## TOWN OF JEROME

Zoning Administrator Analysis Design Review Board Tuesday, September 24, 2024

**Location:** 111 Main Street **Applicant/Owner:** Eric Jurisin

**Prepared by:** Will Blodgett, Zoning Administrator

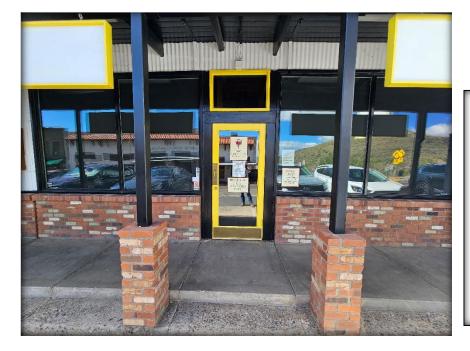
**Response:** The removal of one sign surface and addition of one facing a new direction will not increase the signage area beyond the allowable maximum square footage.

**Response:** The mounting locations for the signage already exists in place, and was used prior to the Pandemic for "Grapes". The proposed signage includes reusing these two existing signs (Each measuring 20" x 108", or 1.6' x 9', or 14.4 sq. ft. each) as well as the name "Haunted Pizano" applied to the entrance along with the hours of operation. Note that the hours of operation and locational information as well as service information are not counted in the total square footage of the sign. Each hanging sign is under the required 16 sq. ft. maximum size and together total to 28.8 sq. ft. of hanging signage, well under the maximum signage area of 32sq. ft.

Proposed Signage locations. Note that the Yellow trim around the border of the signs will be changed to red, while the interior of the sign board will change to black with white lettering. The above image has aa faint graphic on the four window locations, however the applicant has removed that as the total square footage of the signage would exceed the 32sq. ft. allowed.
